573-575 CONGRESS STREET

Memorandum from Department of Building Inspection, Portland, Maine

AP- 575 Congress St., corner of Forest Ave.

SUBJECT: Building 575 Congress Street, Portland, Maine.

PLAN - ATTIC FLOOR

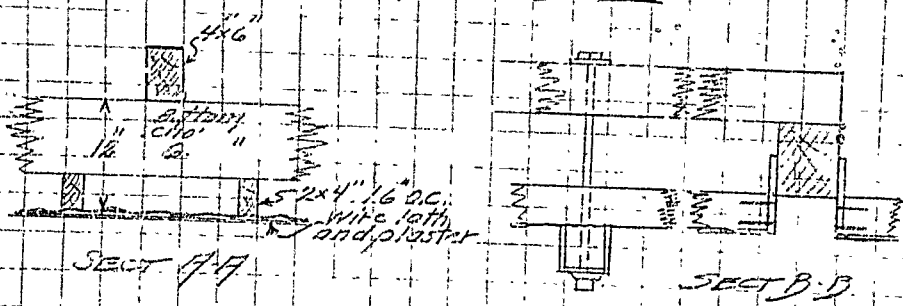
2x4" 16" O.C. 18' apart
1.33 x 18 = 24' x 10 = 240' on each
240' x 216' = 6480' = Sect. Mod of newly 6 Reg. (Bending)
2x4 and 5.3

$$\frac{24 \times 240 \times (18 \times 12)^3}{384 \times 1000000 \times (\frac{25 \times 575^3}{12})} =$$

$$\frac{1209 \times 235200}{37471324000} = 4.4 \text{ in.}$$

Allowable deflection on 18' apart
Actual deflection (metal lath and plaster) $\frac{1}{4}$

This third floor also sleeping quarters for at least four employees. One stairway.

573 CONGRESS ST.
 SIDE DINING ROOM

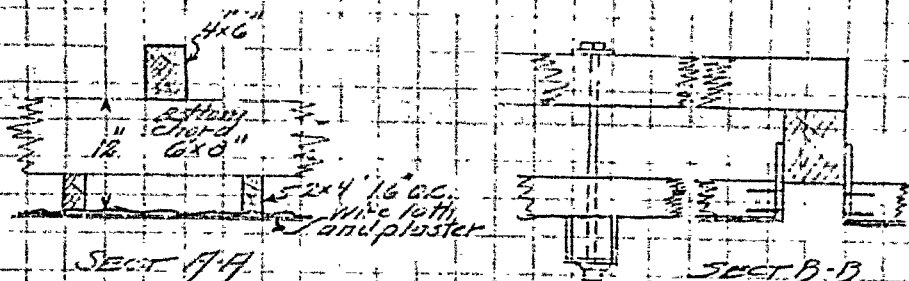
1/33 x 15 = 24' x 10' = 240 sq ft
 240 x 216 = 6780 = 24' x 10' x 216 = 6780
 110' 2 x 4 inch 5.3

$$\frac{54,240 \times (18 \times 12)^3}{18 \times 1600000} = 1.595$$

$$\frac{12,093,235,200}{37,074,624,000} = .4 - 1/4$$

Allowable deflection 1/8" span 16
 Actual deflection (metal with
 and plaster) 1/4"

This third floor also sleeping quarters for
 at least four employees one stairway.
